**City of Portland, Maine – Building or Use Permit Application** 389 Congress Street, 04101, Tel: (207) 874-8703, FAX: 874-8716

**ADDENDUM #1**

TO THE CONTRACT DOCUMENTS FOR:  
SECOND FLOOR RENOVATIONS TO THE  
SALVATION ARMY HEADQUARTERS  
297 CUMBERLAND AVENUE  
PORTLAND, MAINE

**ADDENDUM #2**98.074.4524  
BIM #2

**ASK-1**

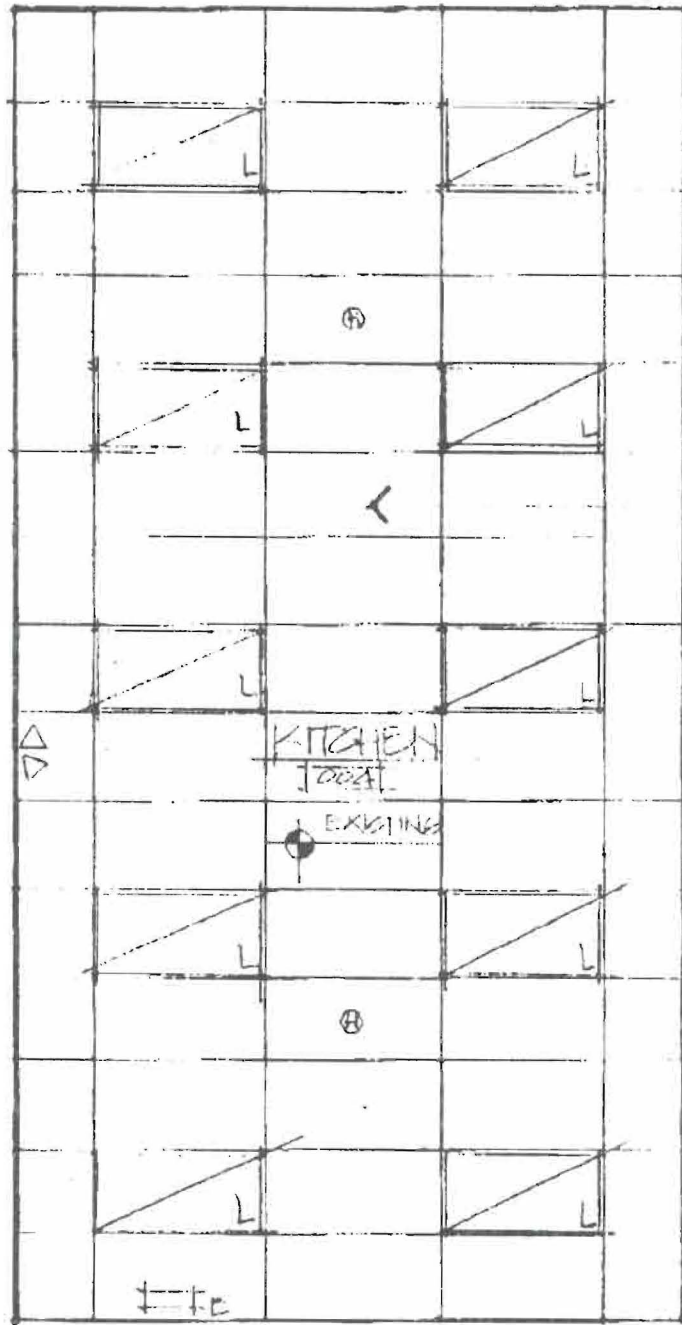
**CHANGES TO THE DRAWINGS**Sheet A4 - Lower Level Reflected Ceiling Plan

1. ADD ASK - 1 Revision to Kitchen 004 in its entirety as attached.

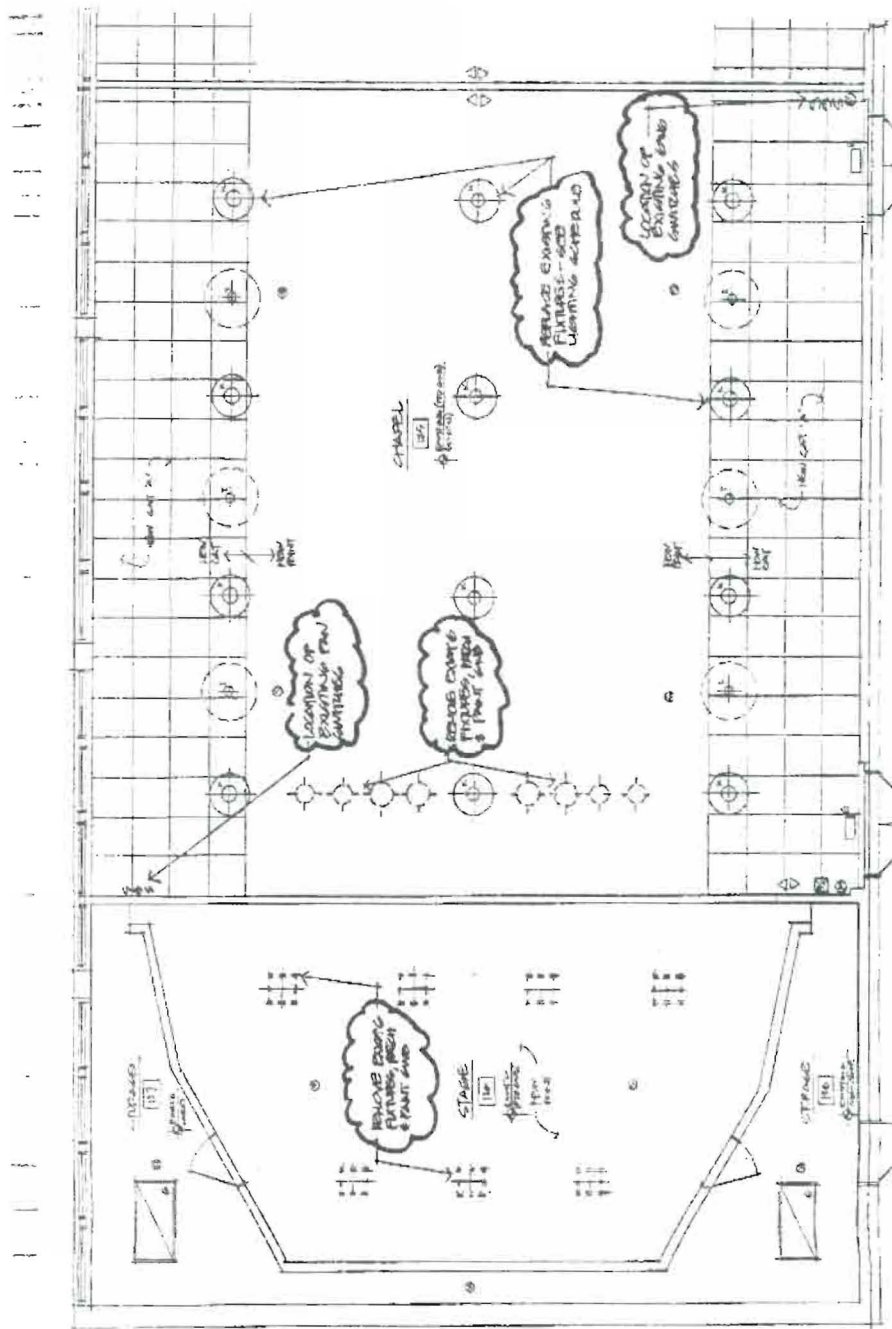
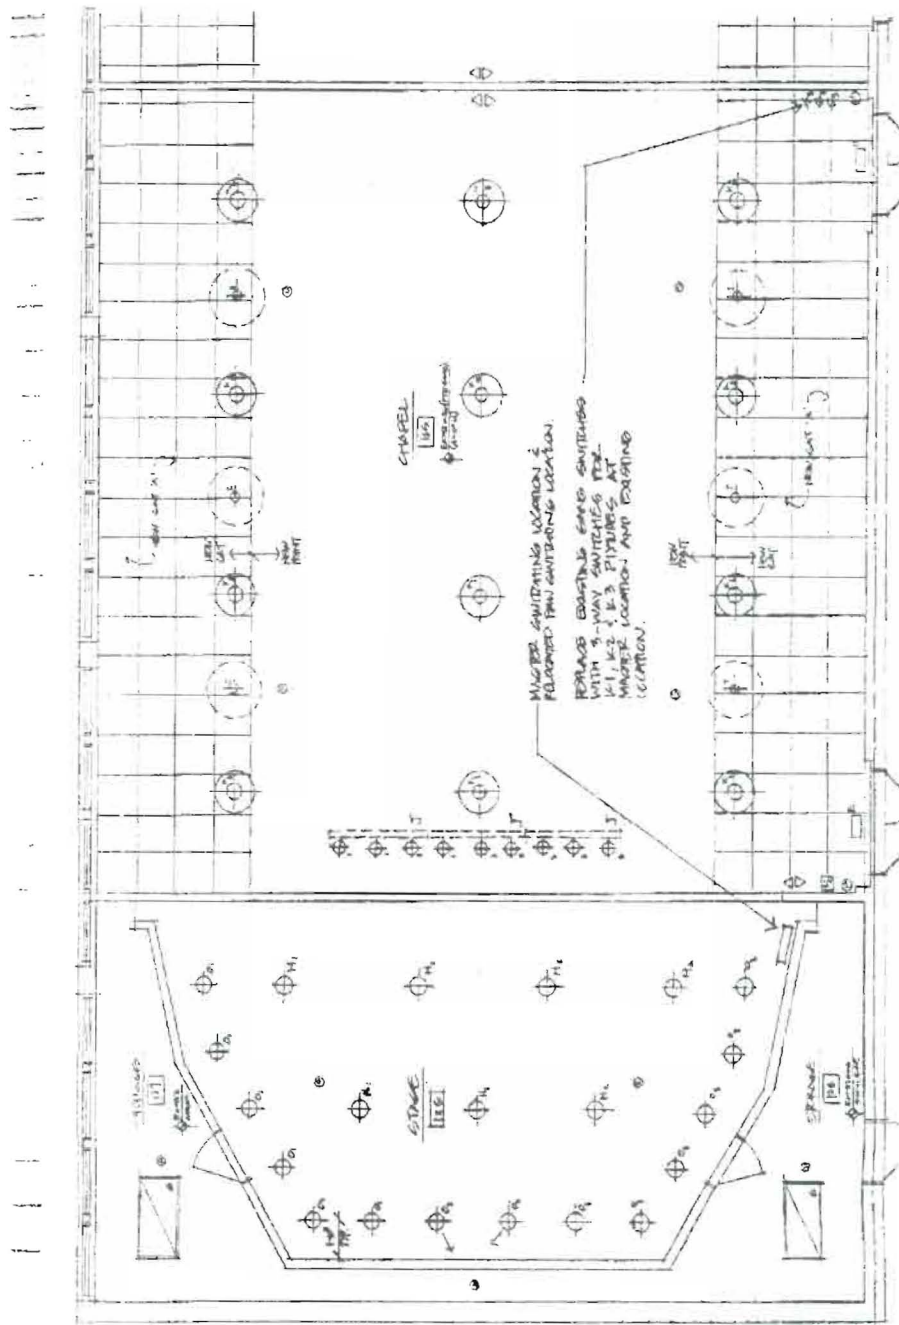
Sheet A7 - Lower Level & First Floor Partial Reflected Ceilings

1. Revise Stage 126 and Chapel 125 lighting layout and switching per ASK - 2 & ASK - 3 as attached in their entirety. Patch & paint sheet rock ceilings to match adjacent surfaces at removed fixtures.
2. Clarification: Replace all existing suspended ceiling tile with SAT A or SAT B (match existing sizes) to accommodate installation of new fire alarm and sprinkler systems. Existing suspended ceiling grid to remain. Remove and reinstall grid sections as needed to facilitate the work. Suspended ceiling grid shall be cleaned and touch-up painted where damaged or where ceiling tile removal has caused blemishes prior to installation of new ceiling tiles.

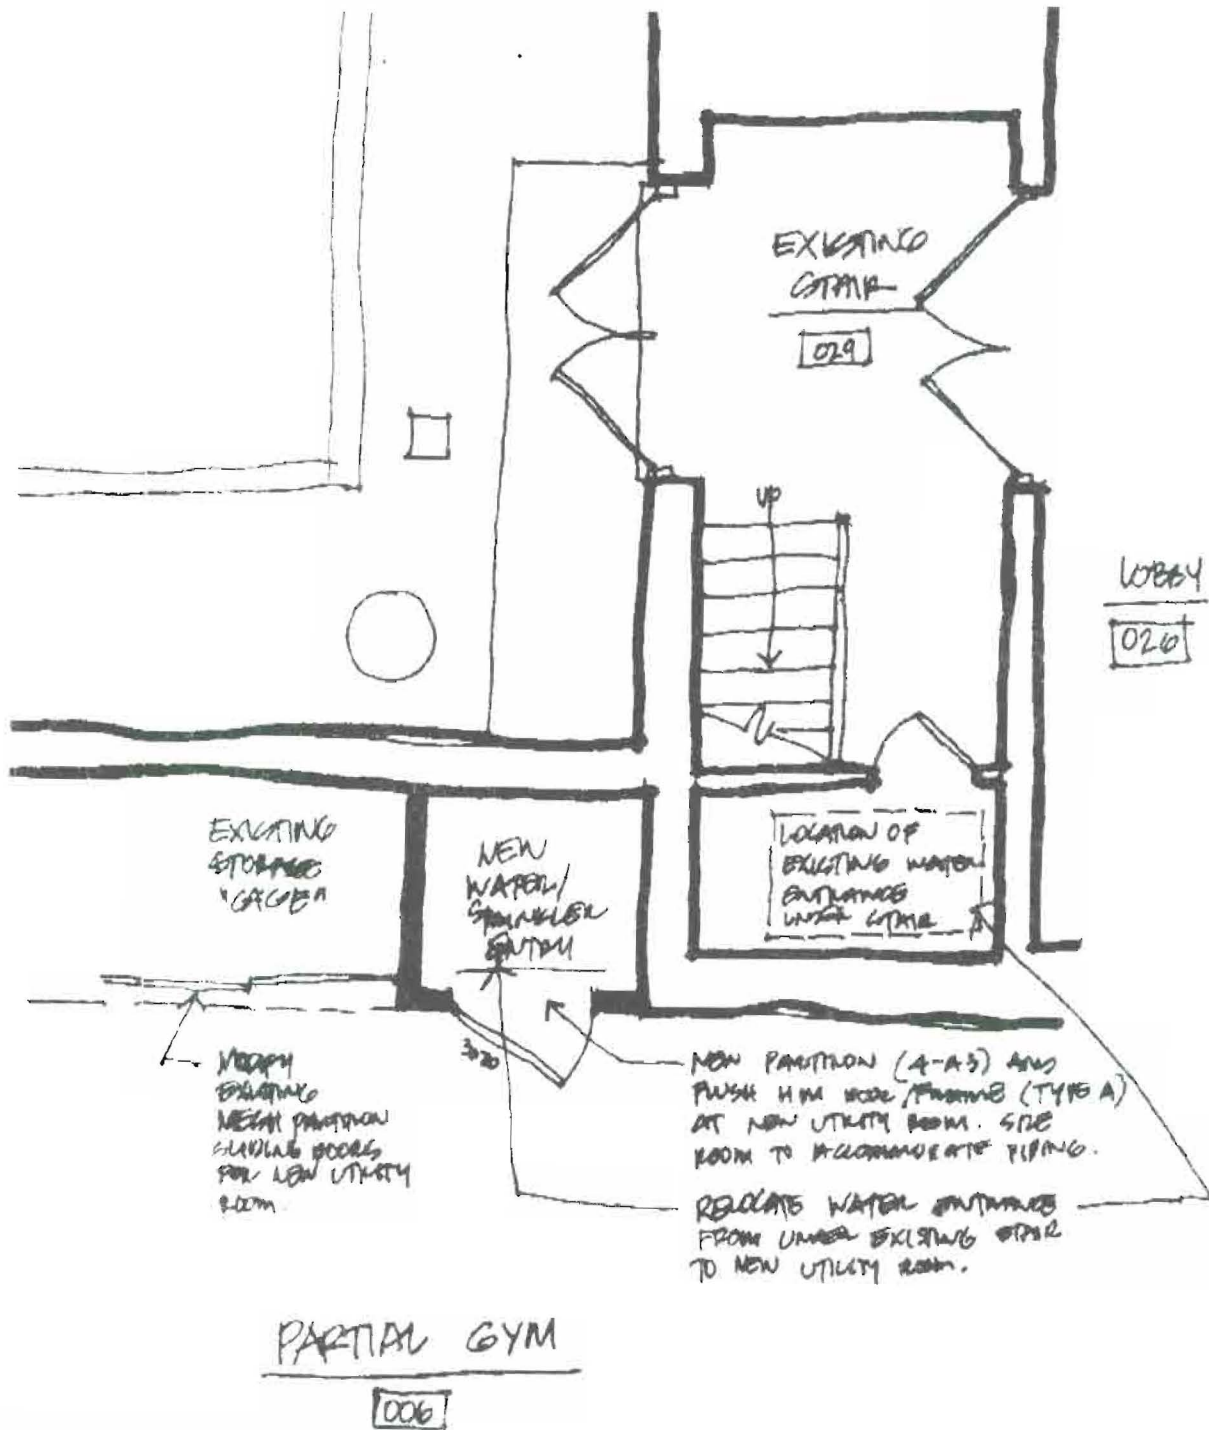
Clarification: Design-build sprinkler system shall have sufficient capacity to accommodate the future three (3) story addition. The addition shall have a footprint of 50' x 60' with a total area of 9,000 square feet. This contractor shall be responsible for all work necessary for upgrading the existing water entrance as required to accommodate the new sprinkler system, including securing all permits from the authorities having jurisdiction. Contractor shall be responsible for site work and relocation of existing water entrance from Stair 029 to new enclosed utility closet at the existing storage off Gym 006. See ASK - 4.

Sheet A4 - Lower Level Reflected Ceiling Plan

Add Ask - 4 in its entirety.
